DELEGATED AUTHORITY CONSULTATION REPORT 7508

**TRAFFIC ORDERS – 30 GROSVENOR SQUARE (FORMER AMERICAN EMBASSY)
(Drawing Nos. 70032286-TMO-02 and 7508/JH)**

(West End Ward)

SCALE @ A1	DATE	DESIGN/DRAWN	CHECKED	APPROVED	SHEET
1:250	08.01.2020	LB	CM	DD	A1
WSP PROJECT NO.	FMC PROJECT NO.	WVC PROJECT NO.			
70032286	WWESA2236	C.WD12539			
DRAWING No.	70032286-TMO-02				REV.
					A

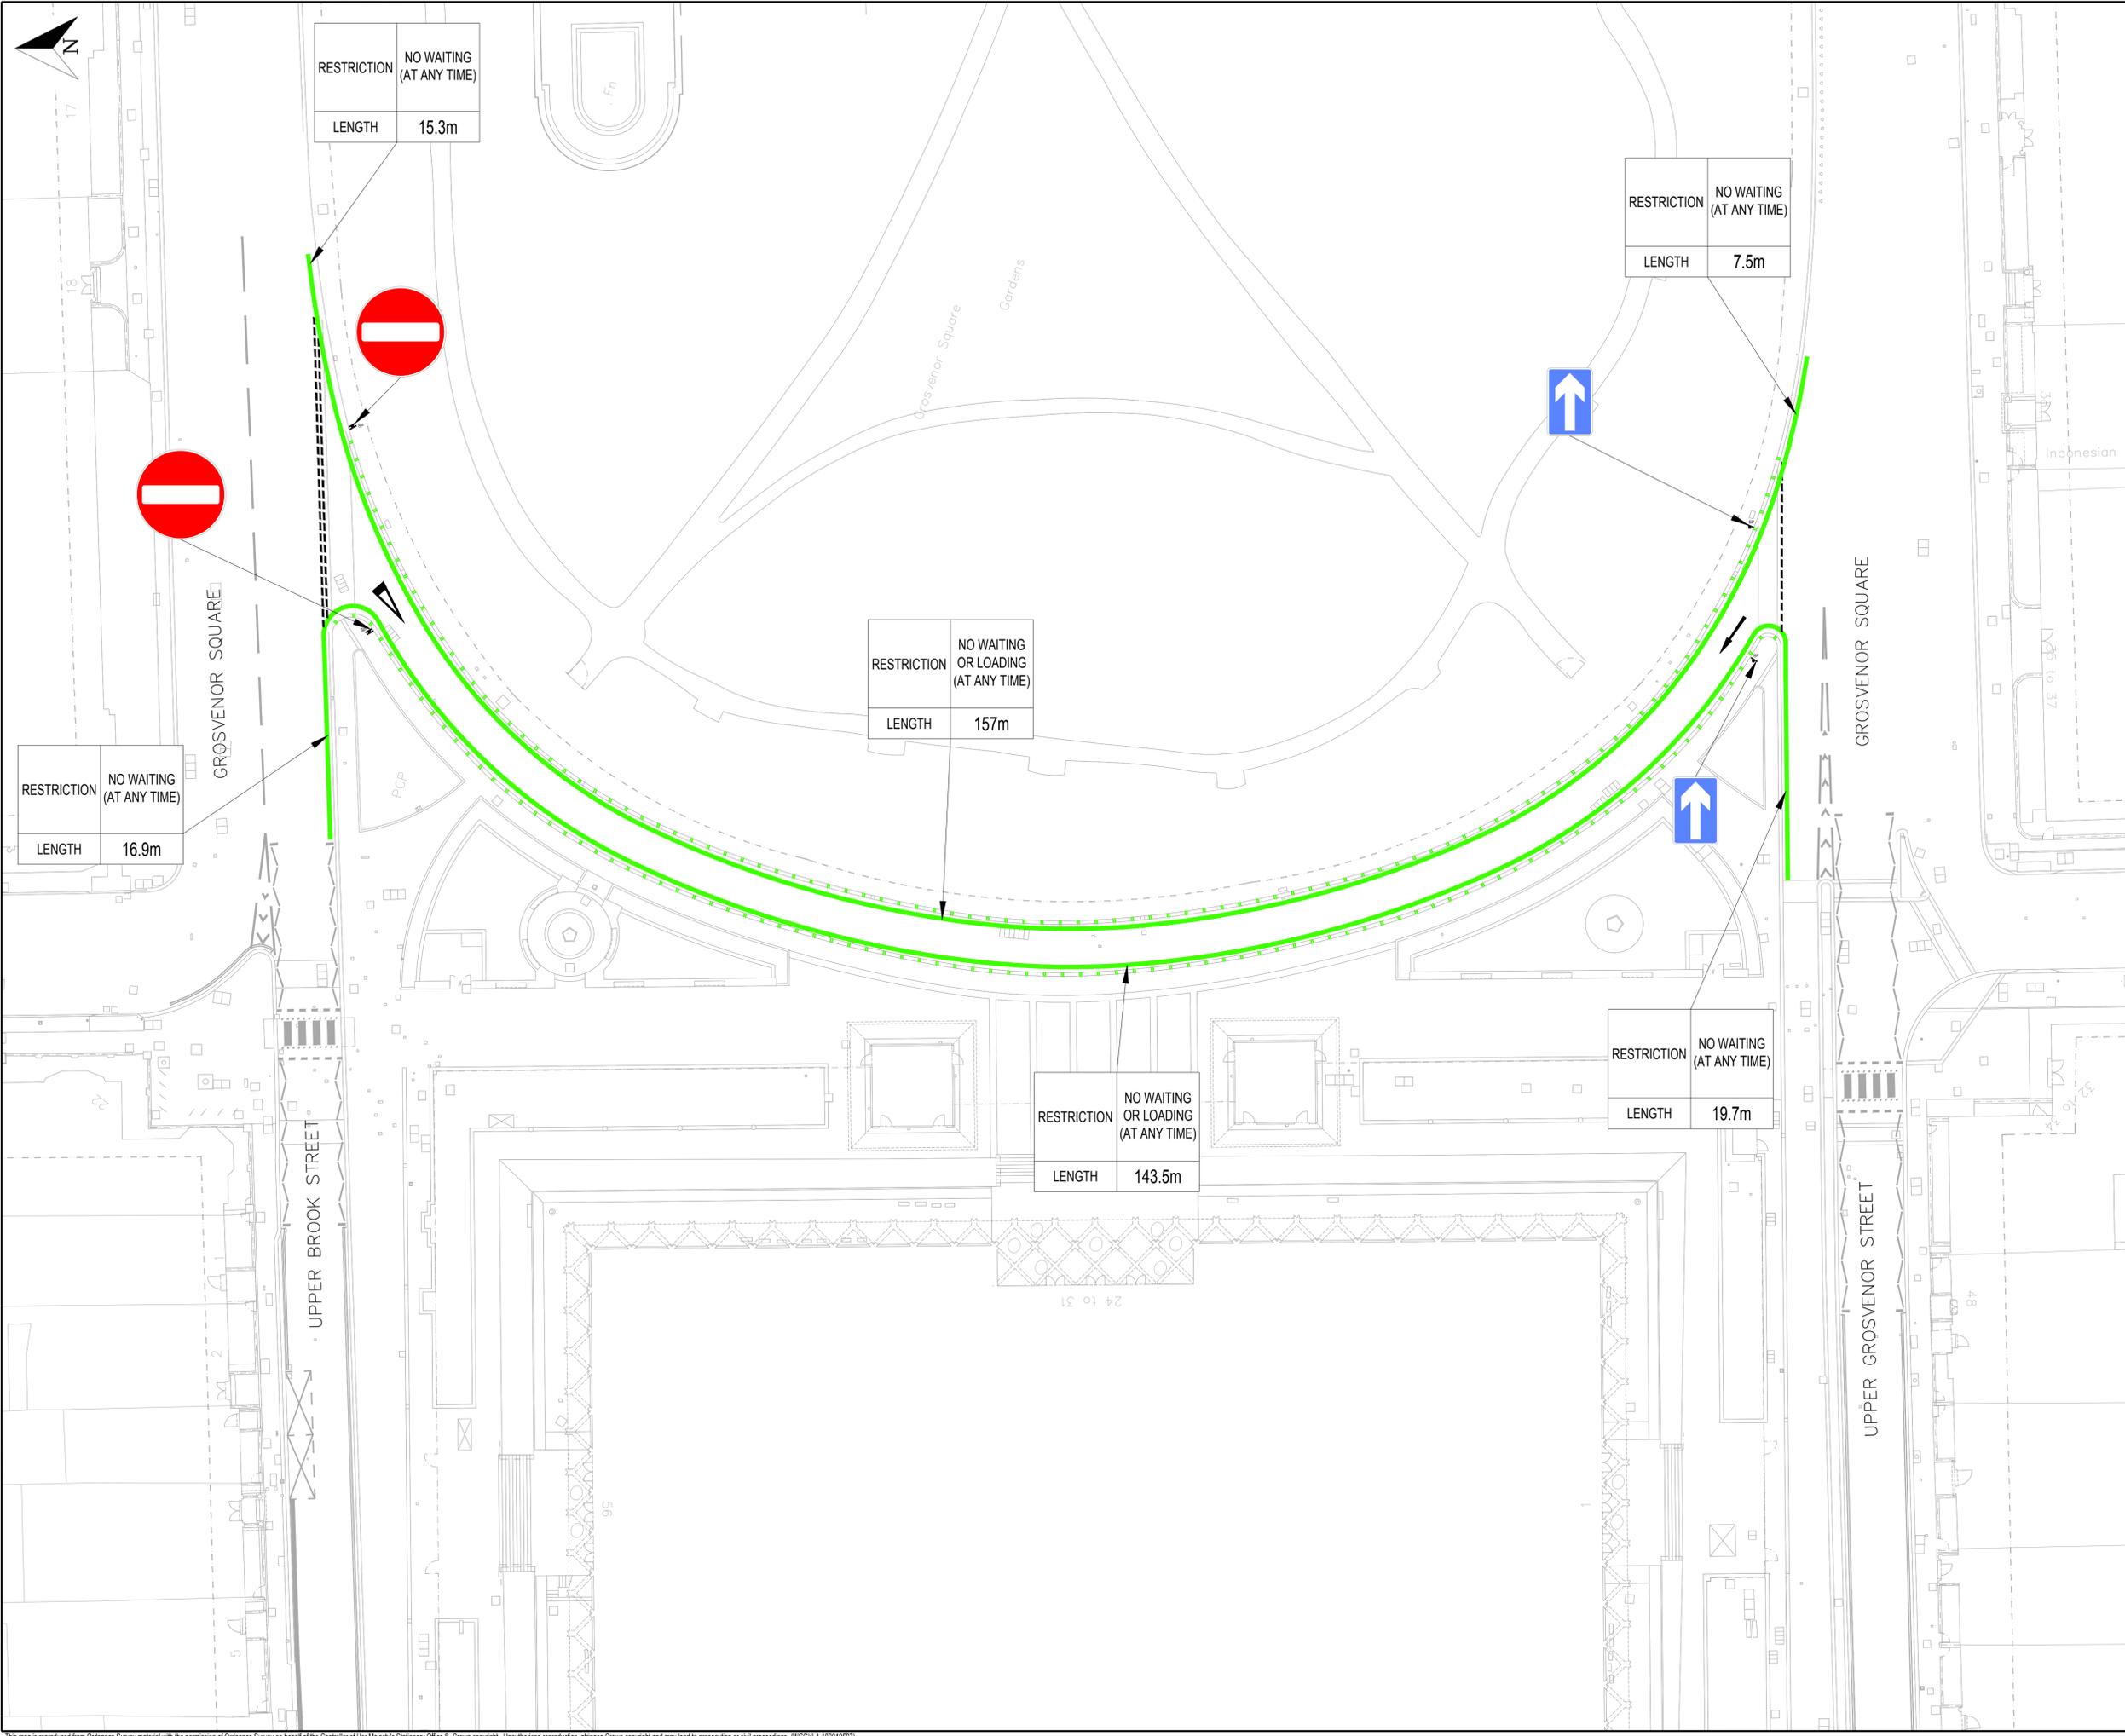
GROUNDS OF OBJECTION	OFFICERS' COMMENTS
1. Policy / Strategy (Air Quality, Pollution, etc.)	
<p>The western arm of Grosvenor Square should not be reopened to traffic on the following grounds:</p> <ul style="list-style-type: none"> • It is contrary to the City Council's, the Government's and the Mayor of London's policies and strategies for cleaner air and streets, sustainable transport, reduced traffic and more space for pedestrians and cyclists; • Increased levels of pollution and poorer air quality which would conflict with the City Council's declaration of a climate emergency; • The Square already exceeds World Health Organisation (WHO) noise targets and air quality targets - increased traffic flows will worsen these. 	<p>There is clearly strong opposition to the re-opening of the western arm of Grosvenor Square, including a detailed submission from Grosvenor Britain and Ireland (the main points of which have been summarised).</p> <p>However, the proposal is a condition attached to the granting of planning permission to Qatari Diar (the developer of the Hotel). It must be stressed that the reopening of the western arm of Grosvenor Square is an interim measure and not intended to be permanent.</p> <p>The Grosvenor Estate, the developer and the City Council have a tri-party agreement and, whilst the interim measures do not align with Grosvenor Estate's current policy and vision for Grosvenor Square, it is imperative that the developer adheres to the conditions set out in the planning permission.</p> <p>A further phase of works associated with the hotel development is anticipated to start within 12 to 24 months and will include improvements to the highway and public realm.</p> <p>Once the final highways scheme is developed it will be subject to a separate consultation in the future. Due consideration will be given to the points raised as a result of this consultation.</p> <p>The City Council will ensure that the final design for this scheme adheres to the City Council's air quality standards and other environmental policies as well as the principles of the Oxford Street District project. As a result, it will be greener, cleaner and smarter.</p>

GROUNDS OF OBJECTION	OFFICERS' COMMENTS
2. Oxford Street District Proposals	
<p>It is contrary to the wider ambitions for the area, particularly the Oxford Street District proposals, including proposed changes to North Audley Street and Park Street.</p>	<p>The Oxford Street District project will incorporate Grosvenor Square and as such will be subject to a separate public consultation.</p> <p>Should the direction of traffic in North Audley Street be reversed as part of the Oxford Street District, this will be factored into the design for subsequent schemes affecting this area.</p>

3. Road Safety	
<p>Pedestrian / vehicle conflicts would increase and road safety in general would worsen with the reopening of the western arm of Grosvenor Square.</p>	<p>The City Council does not consider there is sufficient evidence to suggest that reopening the western arm of Grosvenor Square will result in an increased risk of pedestrian / vehicle conflict.</p> <p>The road has been subject to an independent road safety audit and an assessment by the City Council's Highways Inspectorate and any recommendations made were included in the design for this scheme.</p> <p>The City Council is currently considering a scheme to introduce a city-wide 20mph speed limit in 2020 aimed at improving road safety.</p>

4. Increased traffic flow and congestion	
<p>The reopening of the western arm of Grosvenor Square would lead to a considerable increase in traffic flow and congestion in the Mayfair Area</p>	<p>The City Council will endeavour to prevent negative impacts to traffic flow in the design of the permanent highways scheme at this location.</p> <p>Comments made by the Grosvenor Estate regarding estimated modelled traffic flows are noted. Further traffic modelling will be carried out for the permanent scheme using new traffic flow data gathered once the western arm of Grosvenor Square is re-opened.</p> <p>The City Council will continue to monitor traffic flow and its effects on the surrounding area.</p>

5. Pedestrian and Cycle Routes	
<p>Several respondents have suggested that the western arm of Grosvenor Square should be made a two-way "pedestrian and cycle" zone, with an exemption for vehicles requiring access to the Hotel Entrance.</p>	<p>As referred to in item 1 above, a further phase of works associated with the hotel development is anticipated to start within 12 to 24 months and will include improvements to the highway and public realm, including cycle facilities.</p>

GROUNDS OF OBJECTION	 OFFICERS' COMMENTS
<p>The re-opening would have a detrimental impact on the existing routes used by cycles and pedestrians which are already unsafe and unpleasant.</p> <p>Priority should be given to cyclists and pedestrians to improve safety.</p> <p>A two-way cycle route could be created between North Audley Street and South Audley Street.</p>	<p>Once the final highways scheme is developed it will be subject to a separate consultation in the future. Due consideration will be given to the points raised as a result of this consultation.</p>

3. Access to the Hotel	
<p>The western arm of Grosvenor Square is too narrow if the requirement of the hotel is to accommodate vehicles being able to set down passengers outside its main entrance.</p>	<p>The permanent highways scheme (referred in item 1 above) will allow for vehicles to arrive at the main entrance to the hotel and will be designed to align with the Oxford Street District project.</p>
